UNITED STATES PATENT AND TRADEMARK OFFICE

10/591,627

Office Action Summary	Application No. 10/591,627	Applicant(s) SCHWENDEMANN, FRANZ	
	Examiner DANIEL YABUT	Art Unit 3656

DETAILED ACTION

Figure Y: View of supporting member within rotor drive in the device of Frey et al.

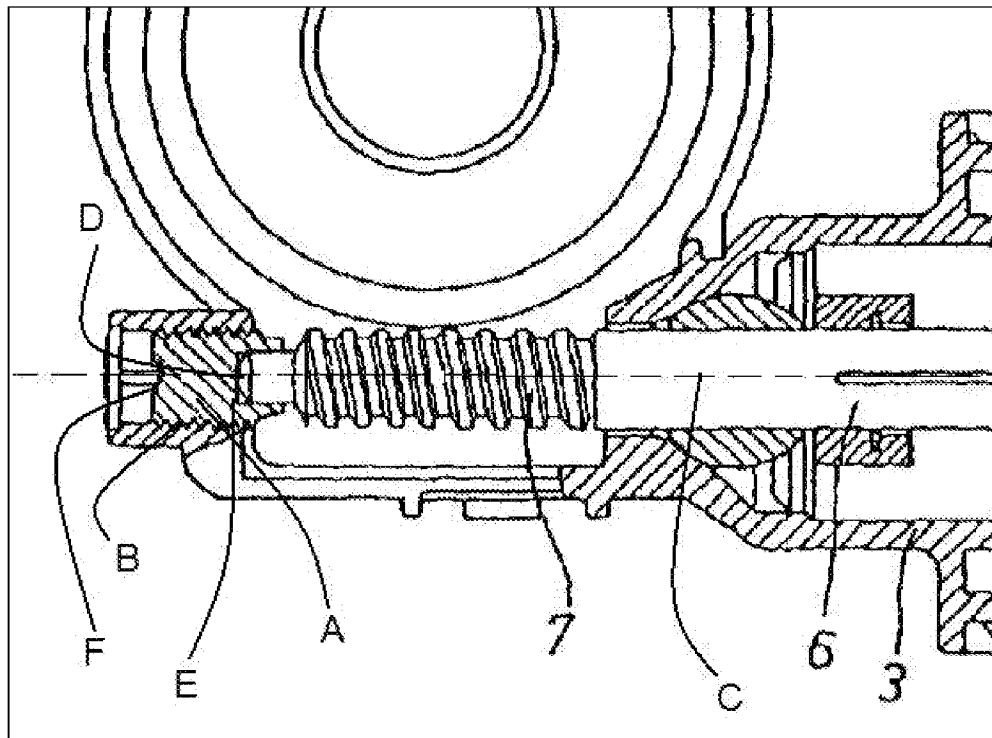
- Rotor (6) positioned with bearings (see bearings near 6 and 14 in Fig. 1) in a housing (Fig. 1)
- Rotor being supported with at least one front face (18) axially on a supporting member (34), which is attached via a form closure on the housing
- Supporting member (A; see Figure Y below) having radial crosspieces (see paragraph [0029], lines 8-10) that can be turned into the housing (3) thereby creating chamfers. **Note:** *Frey discloses the supporting member as a set screw with an external thread, see paragraph [0029], lines 8-10, which is commonly known in the art to be capable of turning into a housing and creating chamfers as described in the specification.*

- Supporting member having a cylindrically shaped base plate (at A; see Figure Y below) having its own cylinder axis (C; see Figure Y below) wherein the base plate has an outer circumference where crosspieces (B; see Figure Y below) are arranged in a plane approximately perpendicular to the cylinder axis (see crosspieces in planes approximately vertical to the cylinder axis C in Figure Y below)

- Crosspieces (B) are arranged in several planes, which are axially spaced in intervals (see Figure Y below)

- Front face of the rotor has a radius (D; see Fig. Y below) that rests against a flat stop surface (E; see Fig. Y below) that is formed on the supporting member

- Advancement of the supporting member (see paragraph [0029] lines 8-14) as well as a notch-like feature (F; see Figure Y below) formed on the support member which is deemed to be a form closed entrainment member.

Frey et al. discloses all of the claim limitations, see above, including an attachment area for the supporting member (at B in Figure Y above) but does not disclose the following, respectively:
